TOLERANCES	WESTERBEKE CORPORATION
UNLESS OTHERWISE NOTED	AVON MA. 02322
INCHES: XX ±.02, XXX ±.010, ANGLES ±.5°, FINISH 64 / MILLIMETERS: XX ±.5, XXX ±.25	TITLE: WIRING DIAGRAM / SCHEMATIC 7.6 BTD
DIMENSIONS: INCHES / MILLIMETERS (ONLY WHEN SPECIFIED)	DRAWN BY: MRM; DATE: 12/June/01; CATEGORY: ; APPROVED BY: ; DATE:
SCALE: NONE	SIZE: E; DRAWING NUMBER: 39284; REV.: G
SHT. 1 OF 1

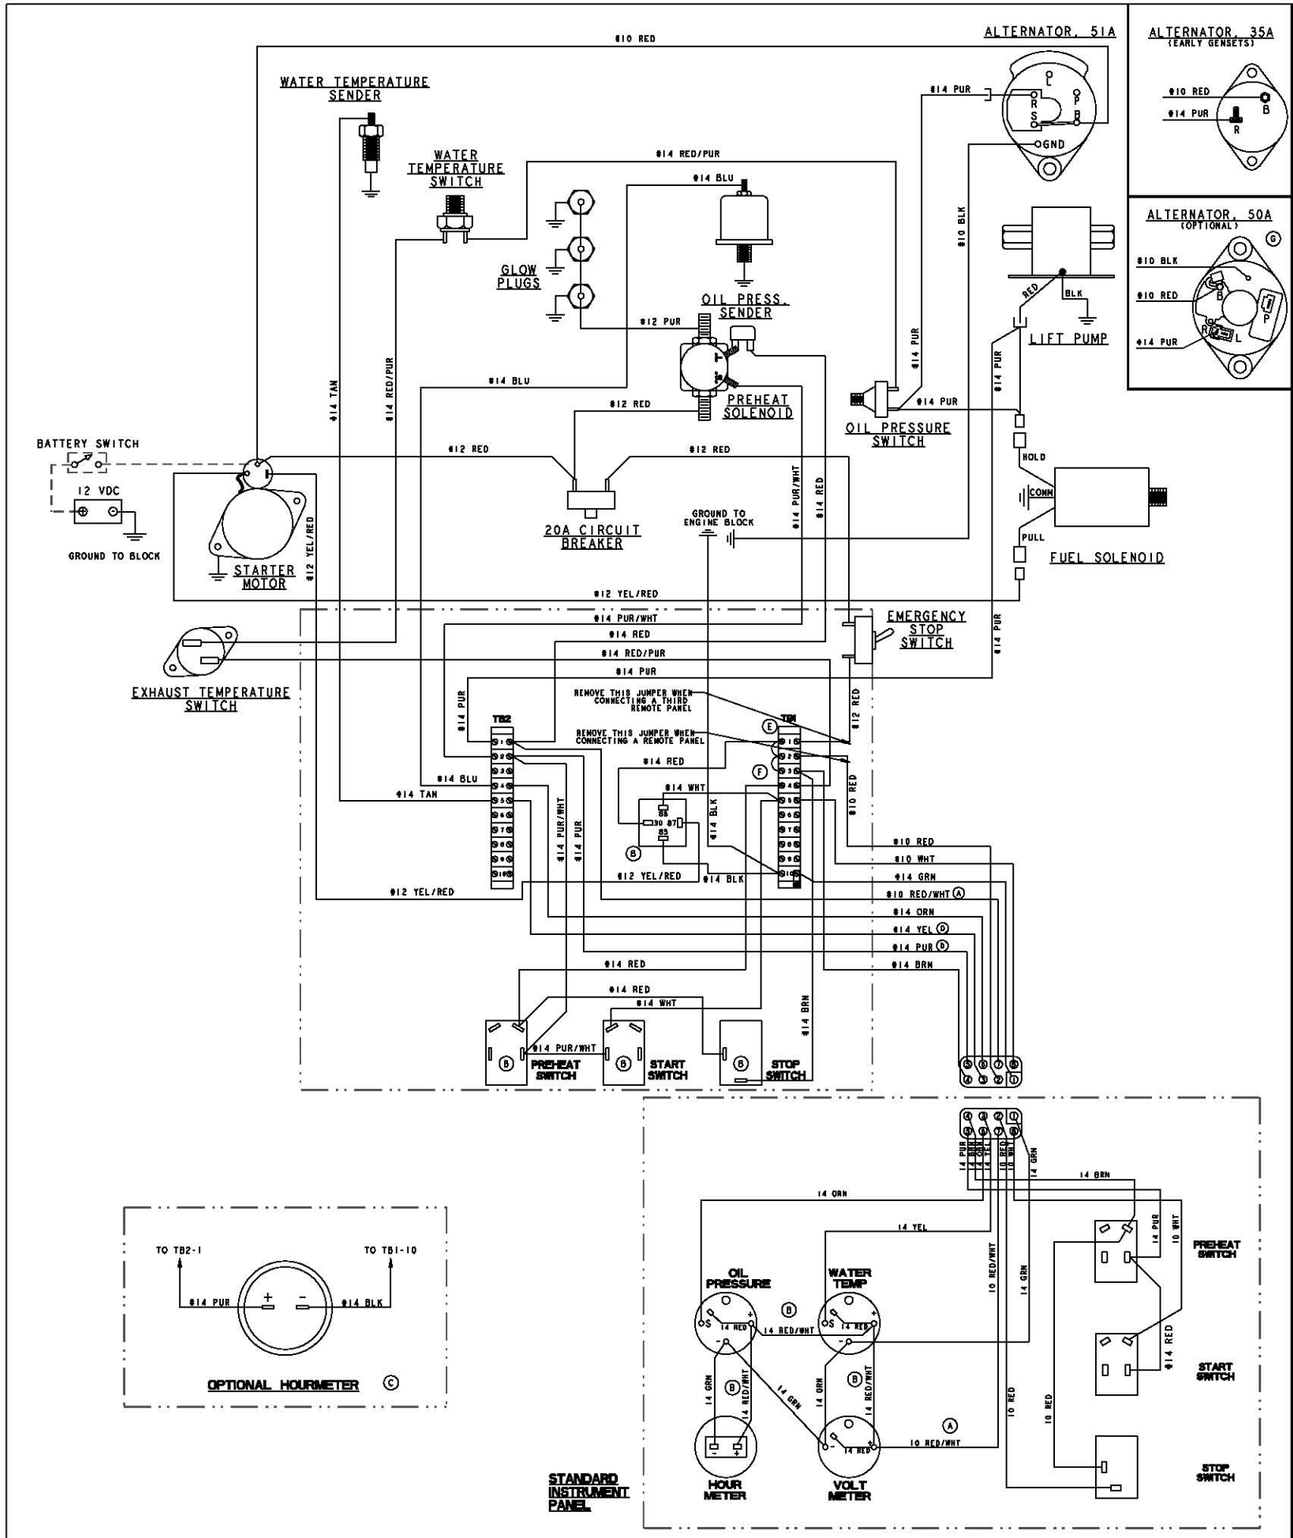
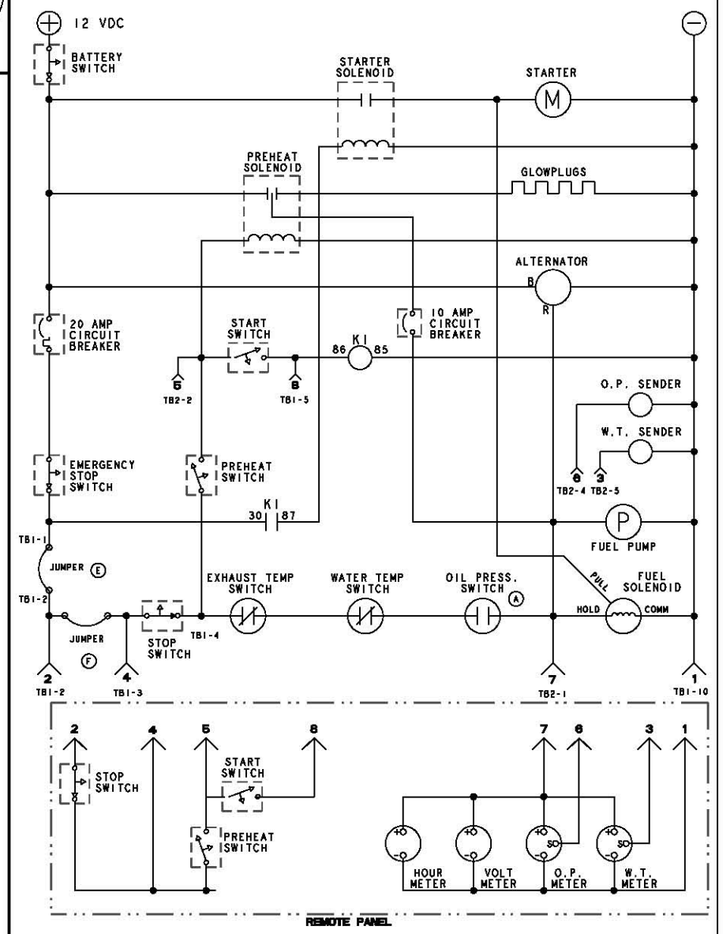
ECO NO.	DATE	REV.	REVISION RECORD	AUTH.	DR.BY
2444	7-20 64	A	CHANGED #10 BLACK WIRE TO #10 RED/WHT; OIL PRESSURE SWITCH WAS "CLOSED", NOW "OPEN"		JLN
2486	8-12 64	B	ADDED 3 SWITCHES,(PREHEAT, START, STOP) TO CONTROL PCB; ADDED #14 ALT. ; ADDED START RELAY TO CONTROL BOX; DELETED #14 BLK WIRE FROM TB1-1 TO TB1-2		WRM
2544	10-7 64	C	ADDED OPTIONAL HOURMETER DIAGRAM		WRM
2596	11-3 64	D	#14 PUR BETWEEN TB2 AND PANEL PLUG WAS #14 YEL; #14 YEL BETWEEN TB2 AND PANEL PLUG WAS #14 PUR.		MKM
2863	11-97 65	E	ADDED TERMINAL BOARD J.(EXCHANGED POSITIONS OF JUMPER AND STOP SWITCH) #14 BLK FROM TB1-1 TO TB1-2; #14 BLK FROM TB1-2 TO TB1-3; #14 PUR FROM TB1-3 TO TB1-4; JUMPER FROM TB1-4 TO TB1-5; #14 BLK FROM TB1-2 TO TB1-5.		MRK
3193	2-10 67	F	ADDED JUMPER BETWEEN TB1-2 AND TB1-5; #14 RED TO TB1-4 FROM TB1-5; #14 BLK TO TB1-3 FROM TB1-2; #14 PUR TO TB1-2 FROM TB1-3; #14 BLK TO TB1-2 FROM TB1-1; #14 PUR TO TB1-3 FROM TB1-2; PLUG 4 TO TB1-5; JUMPER TO TB1-4 FROM TB1-5 REMOTE PANEL ONLY.		MRK

4371	1-13 2000	G	ADDED OPTIONAL ALTERNATOR		JCA
